Access Compliance Report

| Intersection ID: 44824 | Main Street: CLANTON_RD | Cross Street: GOLDEN_RIDGE_LN | Location: NE |
| ADA ID: 994DDECACEA9 | Ramp Type: Perp | Initial Pass/Fail: Pass | Overall Compliance: No |

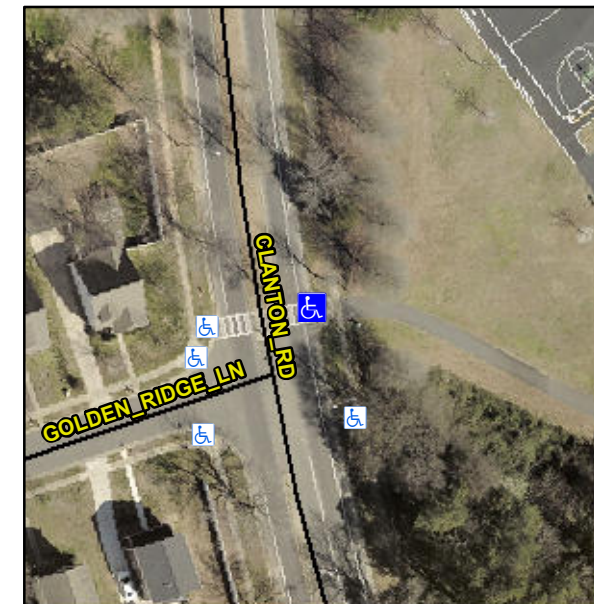
Not Found, R305.1.4

| Compliance | Description | Data | Compliance | Description | Data |
|------------|-----------------------|--------|------------|-----------------------------|------|
| Yes | Landing X Slope (%) | 0.4 | No | DWS Full Width? | No |

Remove & Replace Entire Ramp.
